TORRINGTON PLACE SUBDIVISION

APPLICATION NUMBER 8 DATE November 2, 2006
APPLICANT Torrington Place Subdivision
REQUEST Subdivision

DETAIL SITE PLAN

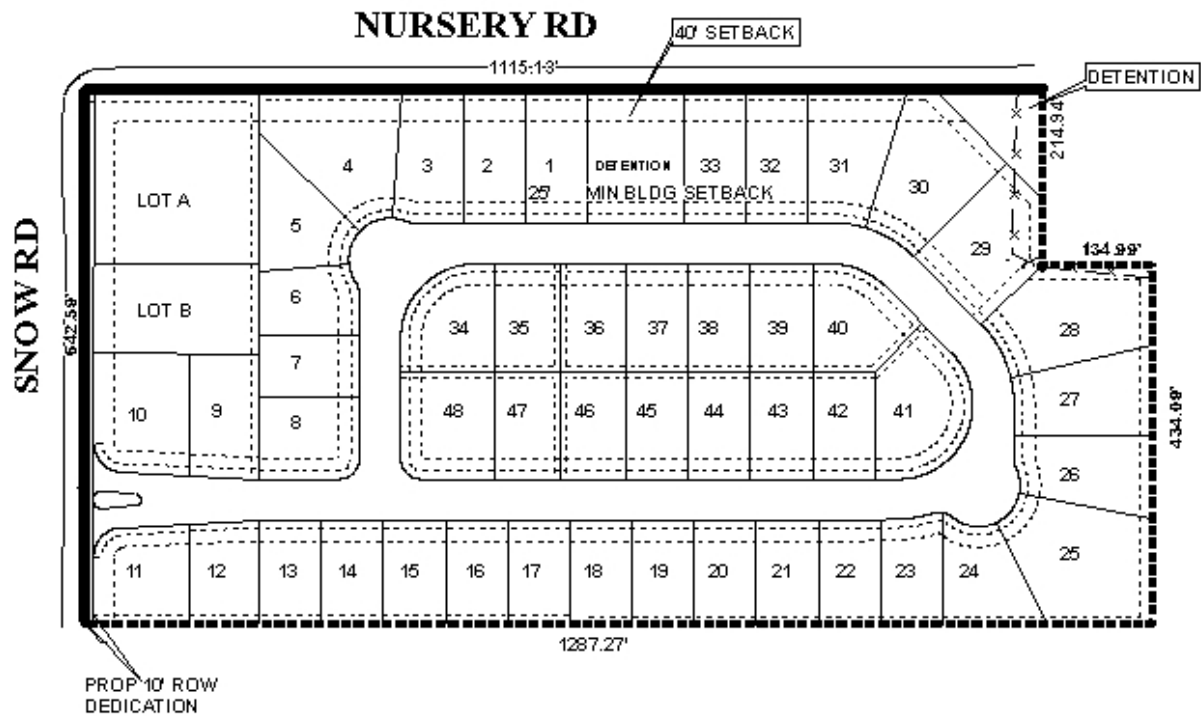
The site fronts onto Snow Road, a proposed major street, and Nursery Road, a minor street. Snow Road should have a right-of-way width of 100 feet instead of the existing 80 feet, and the preliminary plat depicts dedication of an additional 10-feet to Mobile County. Nursery Road has an adequate right-of-way, however, the preliminary plat indicates that the right-of-way is 80 feet, while GIS data indicates the right-of-way may be 60 feet in width: the width should be verified with County Engineering and the plat revised if necessary.

Access management is a concern for the site. The main portion of the subdivision will have access to Snow Road via internal streets, however, some lots will have double frontage. A note should be placed on the plat stating that lots 1-4, 30-33, and the main detention area are denied direct access to Nursery Road, that lots 10 and 11 are denied direct access to Snow Road, and that lot "B" is limited to one curb-cut onto Snow Road, while lot "A" is limited to one curb-cut onto Snow Road and one curb-cut onto Nursery Road. The size, design and location of all curb-cuts are to be approved by the Mobile County Engineering Department. It should also be noted that the detention area located at the Northeast corner of the site will only have frontage onto Nursery Road.

Detention basins are proposed for the subdivision. The detention basins should be labeled as common areas, and a note should be placed on the final plat, if approved, stating that maintenance of the common areas is the responsibility of the subdivision's property owners.

While the site is in the County, the applicant's engineer will be required to certify that the stormwater detention, drainage facilities, and release rate comply with the City of Mobile stormwater and flood control ordinances, prior to the signing and recording of the final plat, if approved.

This site is located in Mobile County, thus a note should be placed on the final plat stating that any lots which are developed commercially and adjoin residentially developed property must provide a buffer, in compliance with Section V.A.7. of the Subdivision Regulations.

Based on the preceding, the plat meets the minimum requirements of the Subdivision Regulations and is recommended for Tentative Approval, subject to the following conditions: 1) verification of the right-of-way width for Nursery Road, and correction of the plat if necessary; 2) the dedication of right-of-way sufficient to provide 50-feet from the centerline of Snow Road,

as depicted on the preliminary plat; 3) placement of a note on the final plat stating that lots 1-4, 30-33, and the main detention area are denied direct access to Nursery Road, that lots 10 and 11 are denied direct access to Snow Road, and that lot "B" is limited to one curb-cut onto Snow Road, and lot "A" is limited to one curb-cut onto Snow Road and one curb-cut onto Nursery Road, with the size, design and location of all curb-cuts to be approved by the Mobile County Engineering Department; 4) labeling all common areas, including the detention basins, and placement of a note on the final plat stating that maintenance of the common areas is the responsibility of the subdivision's property owners; 5) provision of a certification letter from a licensed engineer to the Planning Section of Urban Development, certifying that the stormwater detention, drainage facilities, and release rate comply with the City of Mobile stormwater and flood control ordinances, prior to the signing and recording of the final plat; 6) revision of the plat to label each lot in square feet, or provision of a table on the plat depicting the same information; and 7) placement of a note on the final plat stating that a buffer, in compliance with Section V.A.7. shall be provided where the commercial properties adjoin residential property.
